## Technical Tip

**Model:** HTR-330/530, TX-SR303/SR503

**Subject:** General troubleshooting for Protect problem.

## Service Bulletin

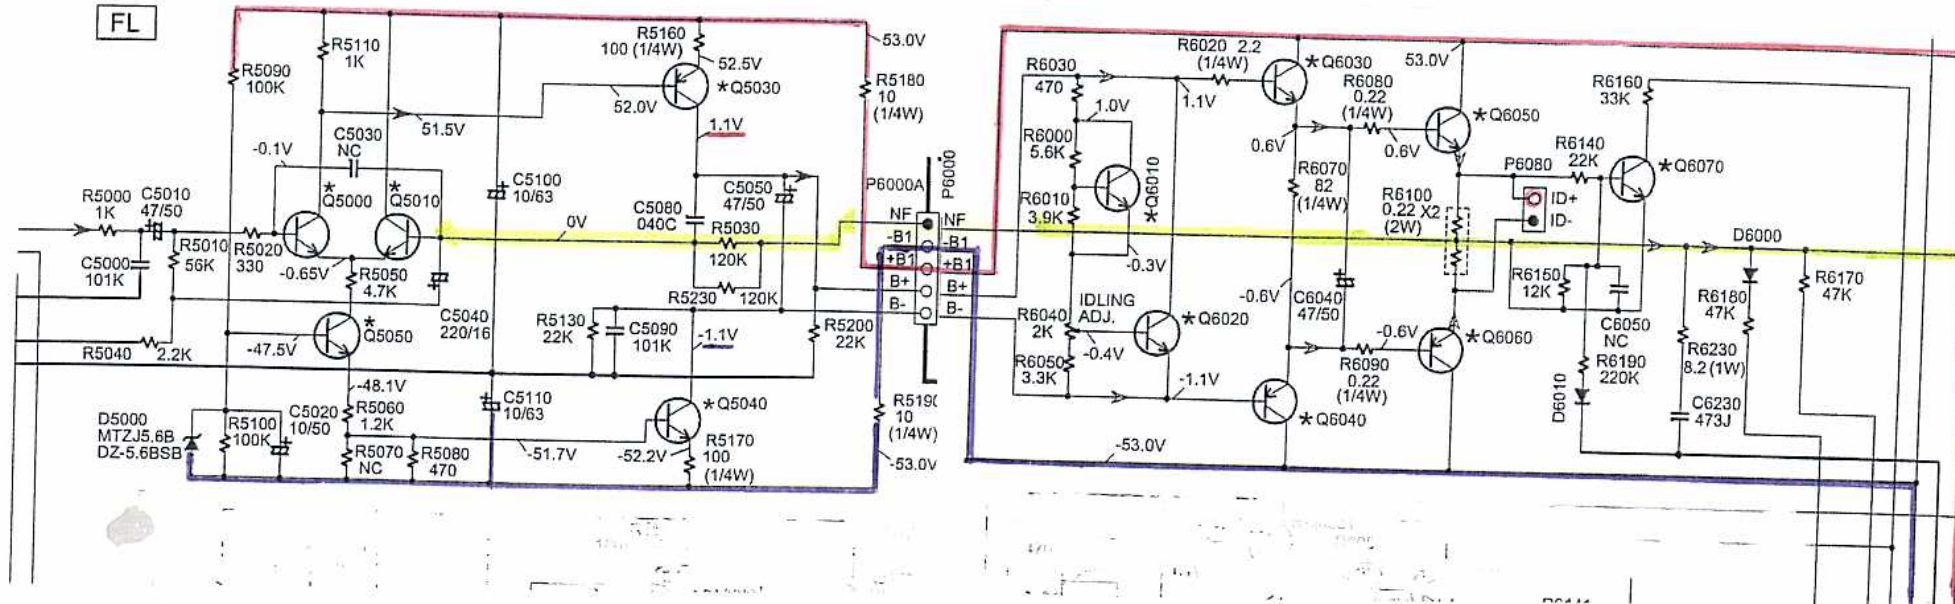
- 1 . Normal audio using analog inputs. Do you have all Dolby surround sound ?
- 2 . All DSP voltages are normal ? Did all supply voltage go to all ICs ? +5vDSP, 2.5V, +3.3V... +7v, -7V..
- 3 . Input sel IC. Use CD analog input audio signal (ADRT+, ADRT- and ADLT+, ADLT-) out to DAC IC ?  
Surround analog signal out (DAC L, DAC R, DAC C, DAC SW, DAC LS, DAC RS, DAC SB\* back to Input sel. IC.  
Pin 1 to pin8 out to p5504. ( Same as pre out) check Mutting transistors Q5600 to Q5617 .
- 4 . When use digital input signal did digital light up on display ?  
If missing 3.3v, 2.5v 5vdsp (on Reg IC Q5640) to DSP ICs will disable DSP function. (U05 Amplifer PC board)

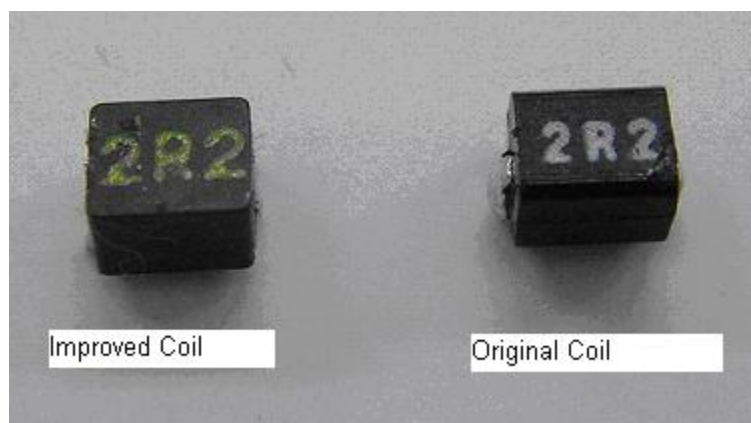
**Symptom:** No sound in Surround mode. Coil L921 which is located on the DSP board may have opened due to in rush current.

**Solution:** Check coil L921, if open, replace L921 with the improved part (green print).
